MATANUSKA-SUSITNA BOROUGH PLATTING BOARD AGENDA

MATANUSKA-SUSITNA BOROUGH PLATTING BOARD AGENDA FEBRUARY 20, 2020

A. LANIKAI ESTATES LLC: The request is create a t-turnaround Public Use Easement at the western terminus of E. Wagonwheel Drive, in Tax Parcel A7, to be known as **OSTERMILLER PUE**, containing 13,286 sf +/- . The proposed Public Use Easement is located west of E. Wagonwheel Drive, parcel is located west of N. Britchenstrap Drive and north of N. Farm Loop, (Tax ID #118N02E18A007); within the E ½ W ½ NE ¼ Section 18, Township 18 North, Range 02 East, Seward Meridian. Community Council Farm Loop and in Assembly District #1 Tim Hale

B. MARY SUSANNE GOODWIN: The request is to create a 58-lot, 2-phase master plan known as **GOODWIN ESTATES**, containing 80 acres +/- . The property is located west of N. Palmer-Fishhook Road and north of E. Tex-Al Drive (Tax ID #18N01E10C007 & 18N01E10D006); within the S ½ Section 10, Township 18 North, Range 01 East, Seward Meridian. Community Council: Fishhook and in Assembly District #6 Jesse Sumner

PALMER, ALASKA
 GOODWIN ESTATES
 PLAN AND PROFILE - DESIGN
 GOODWIN LOOP

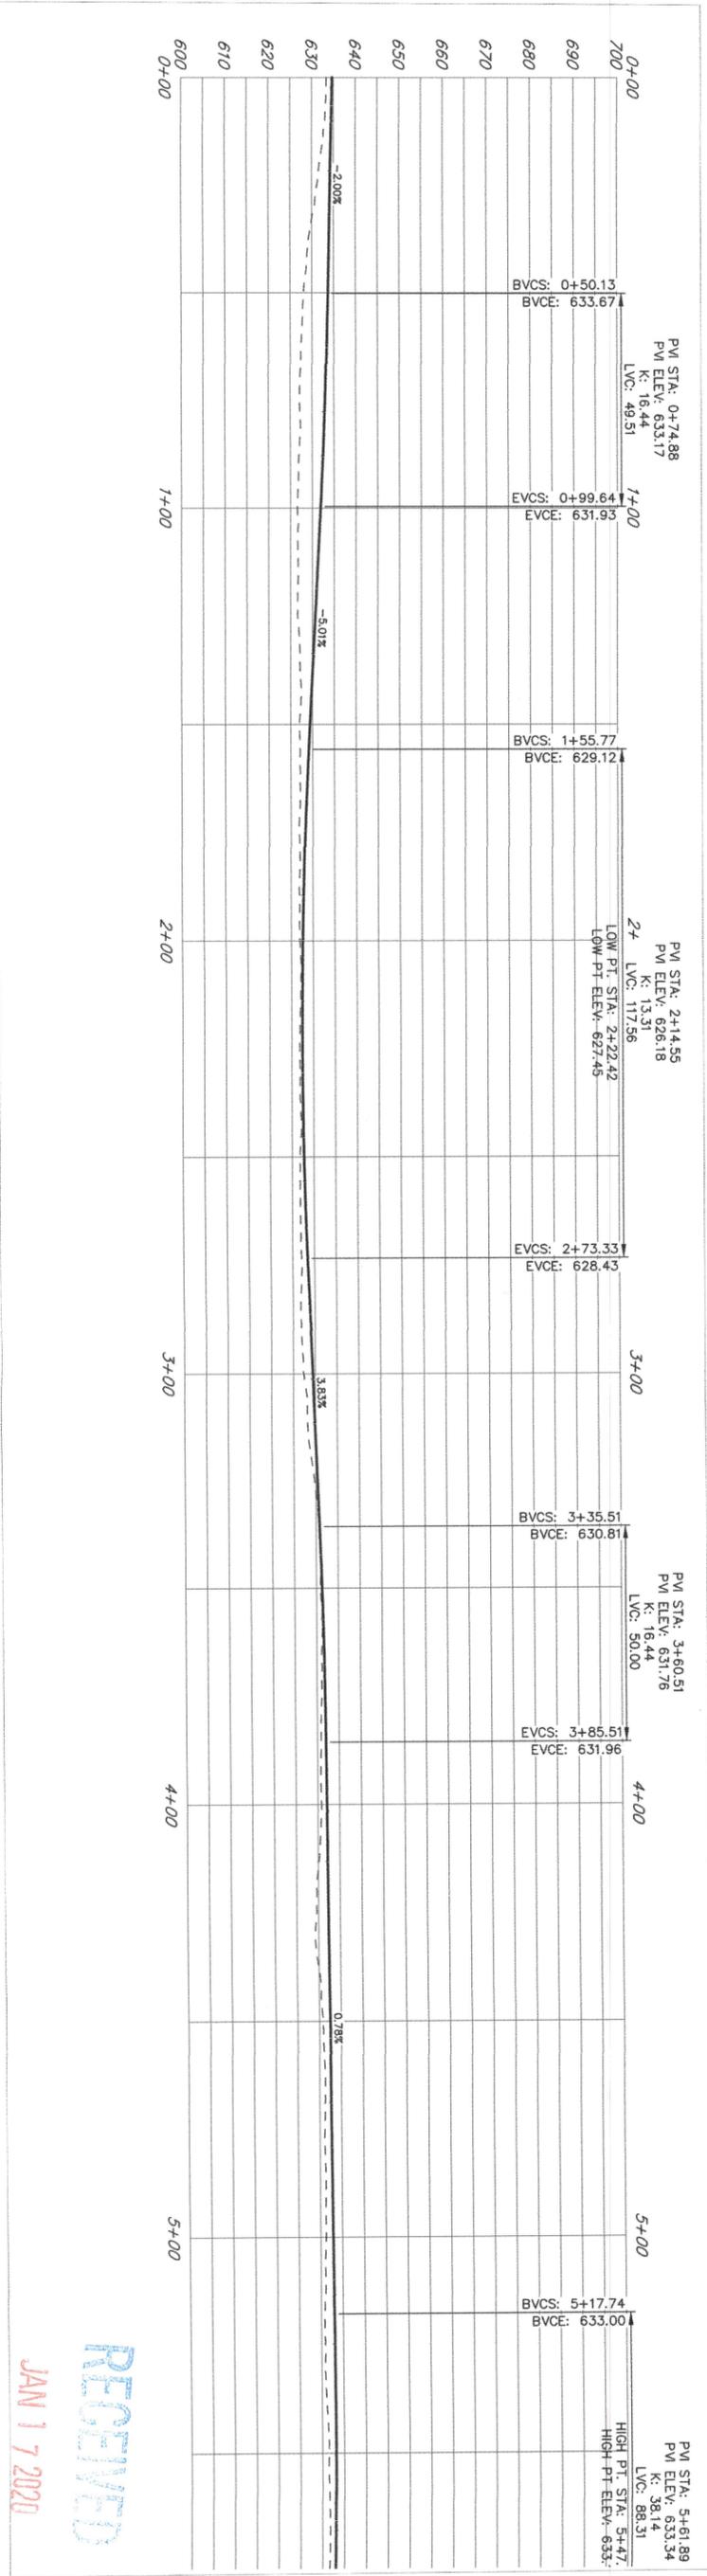
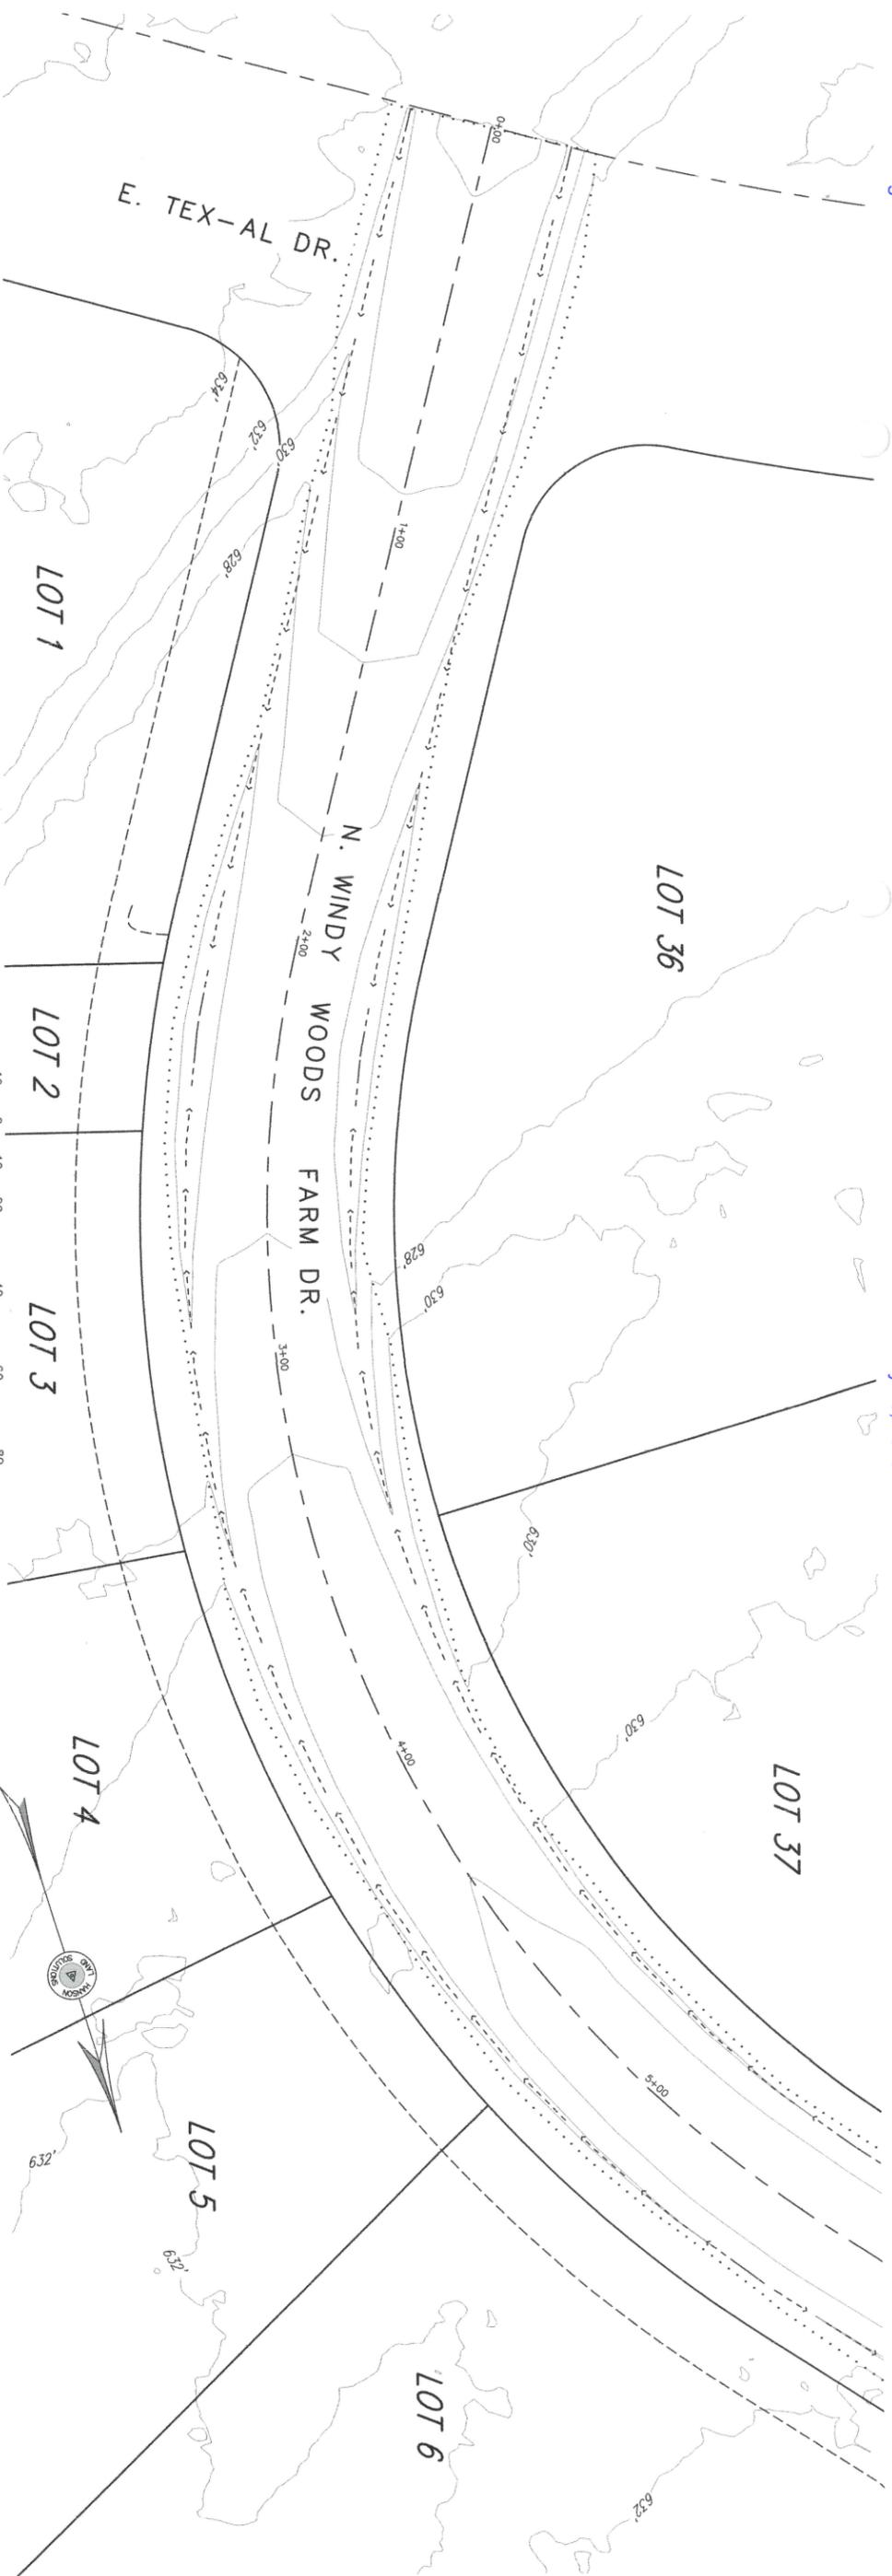
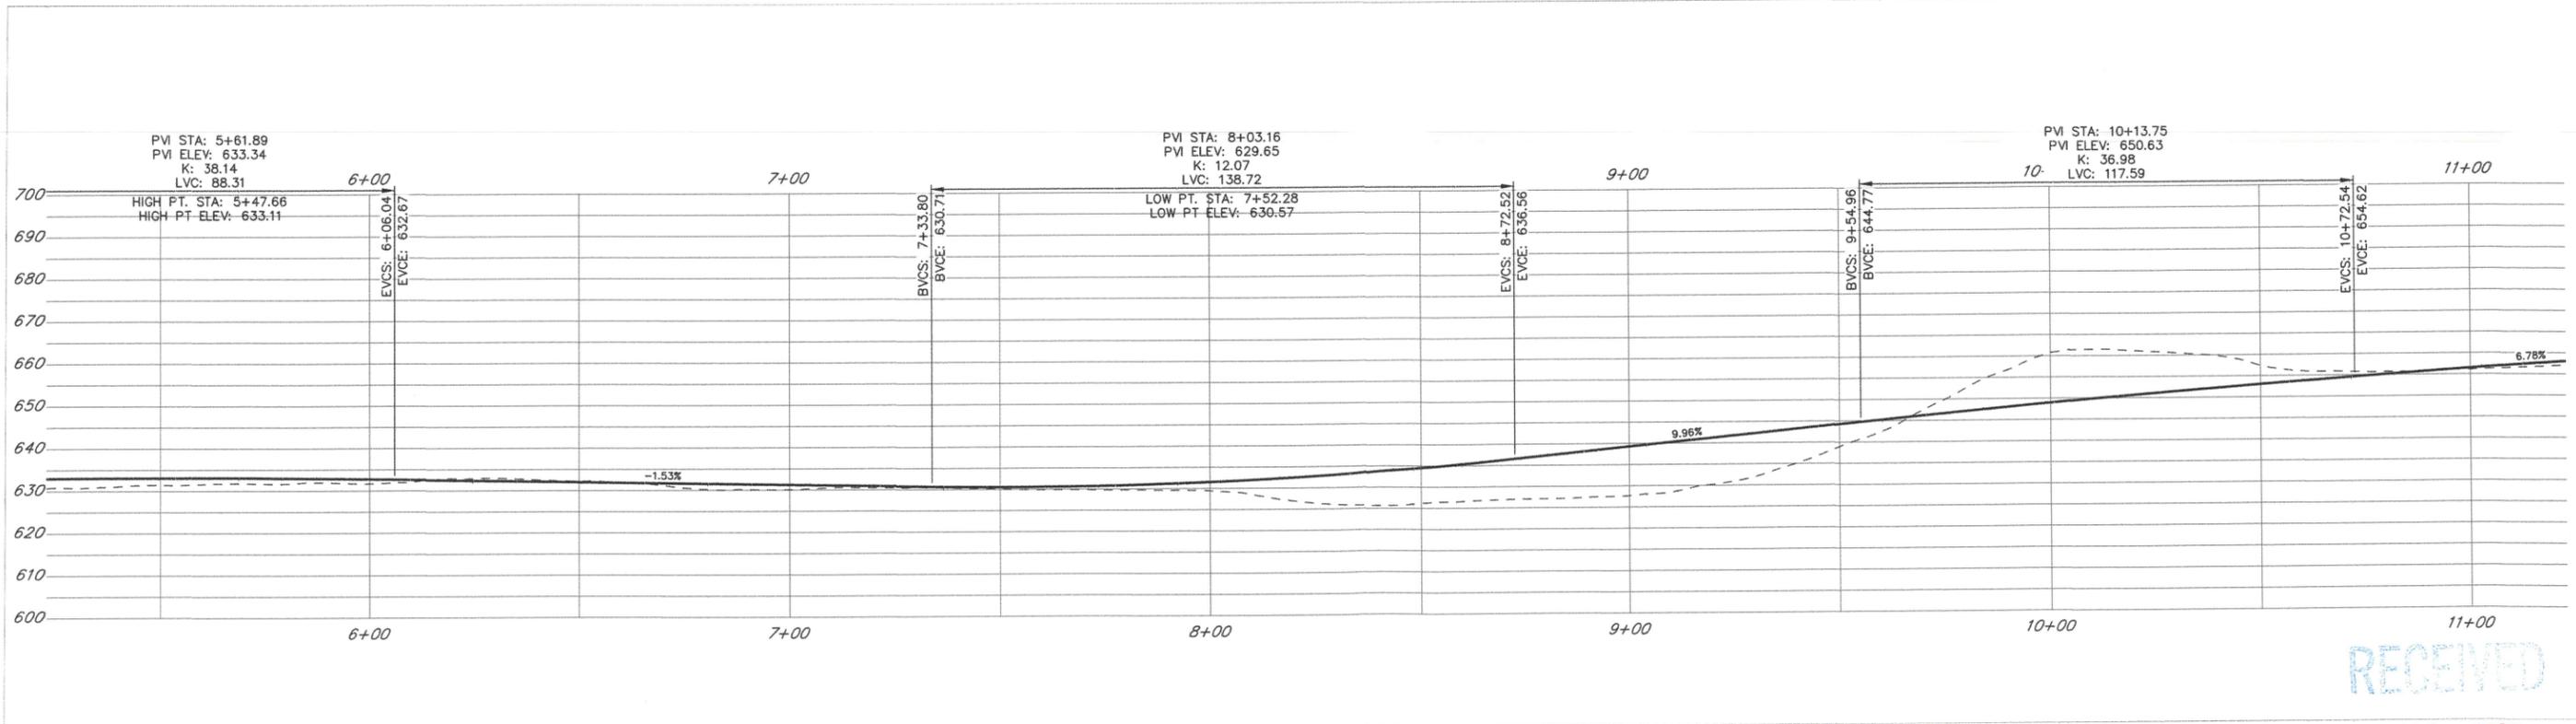
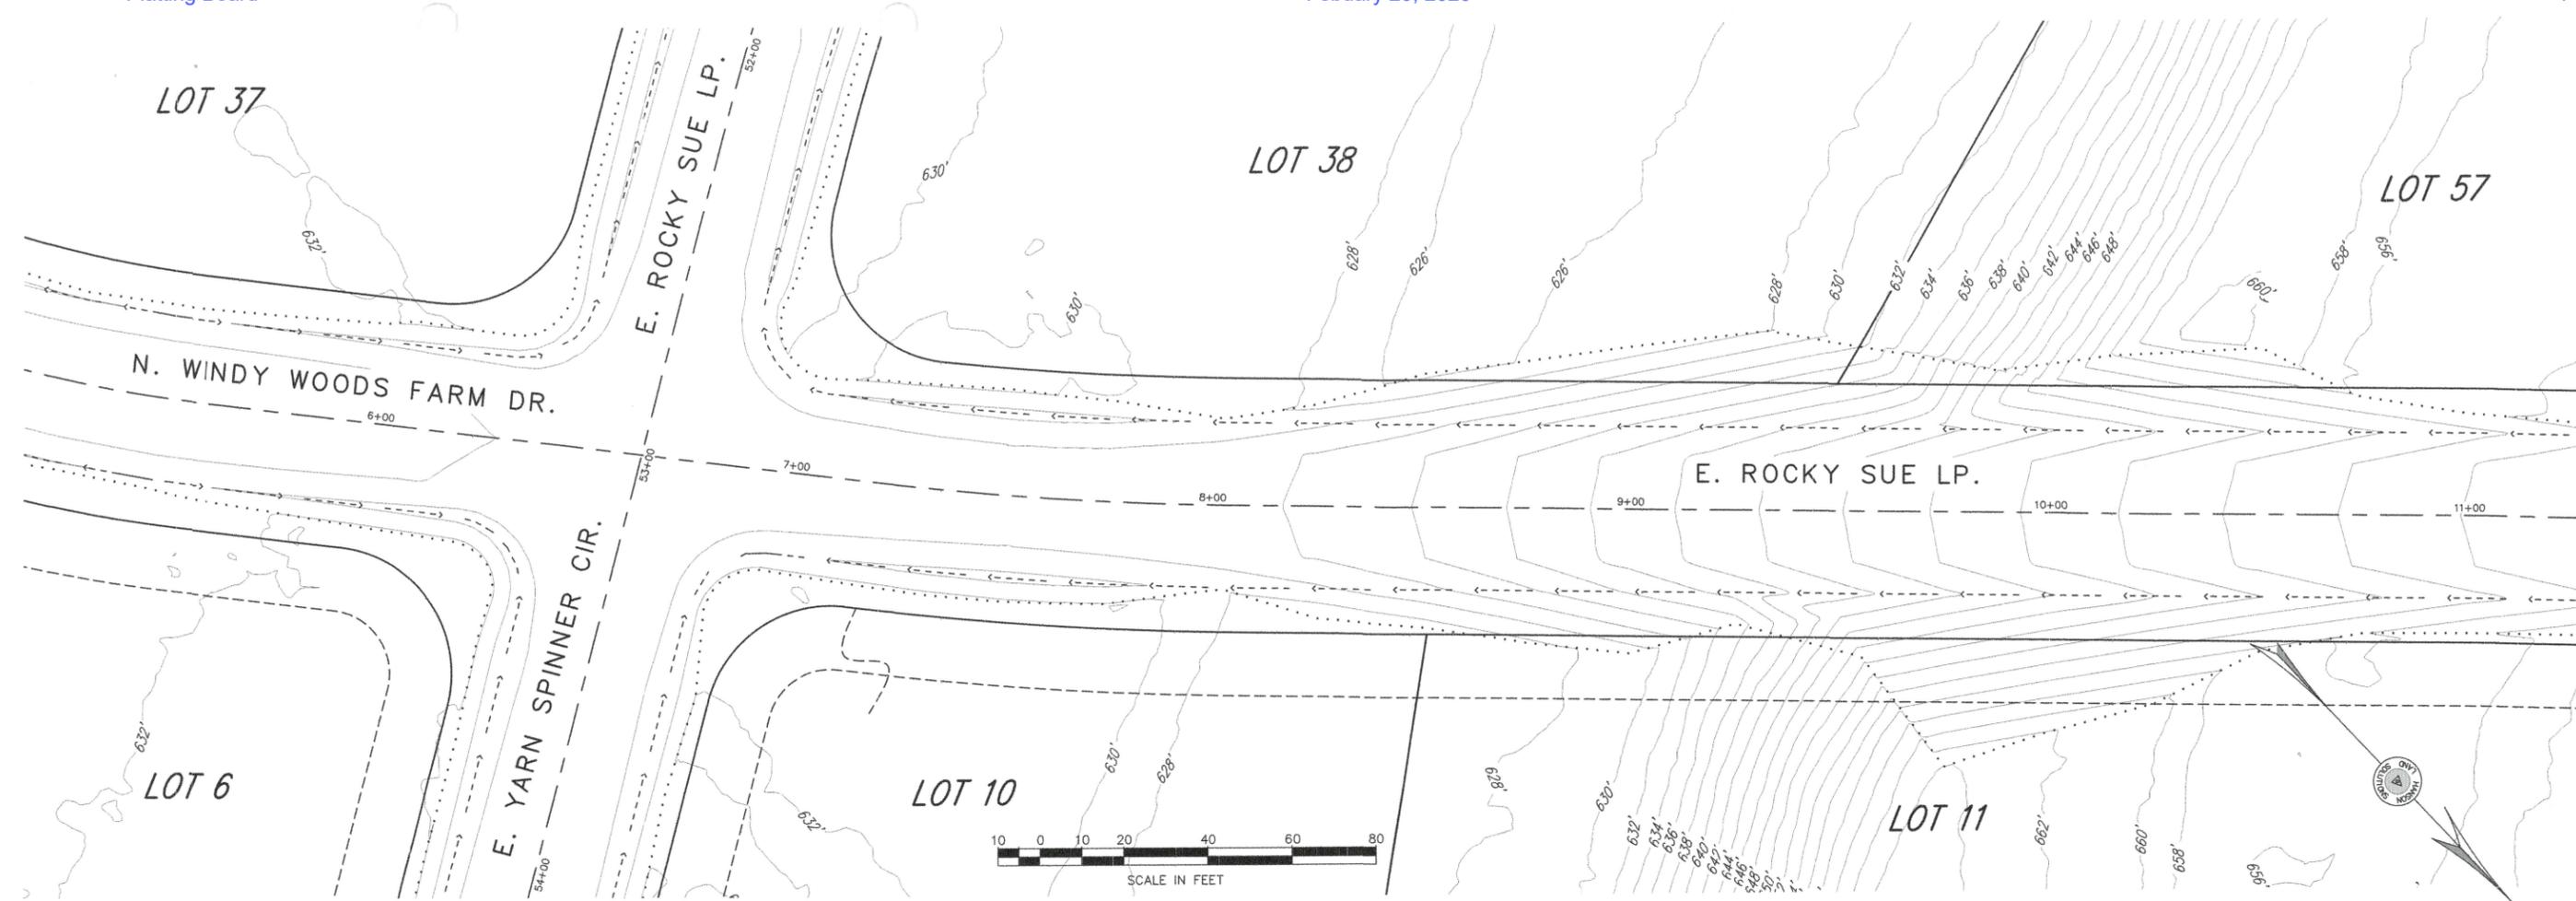
- I approve the less than 350' radii horizontal curves due to the site constraints as stated in the surveyor's letter.
- Plan & profile – A05.5 f) requires maximum grade of 7% within 50 feet of an intersection on the through road – check this at the intersection of the two stub roads with the loop road.
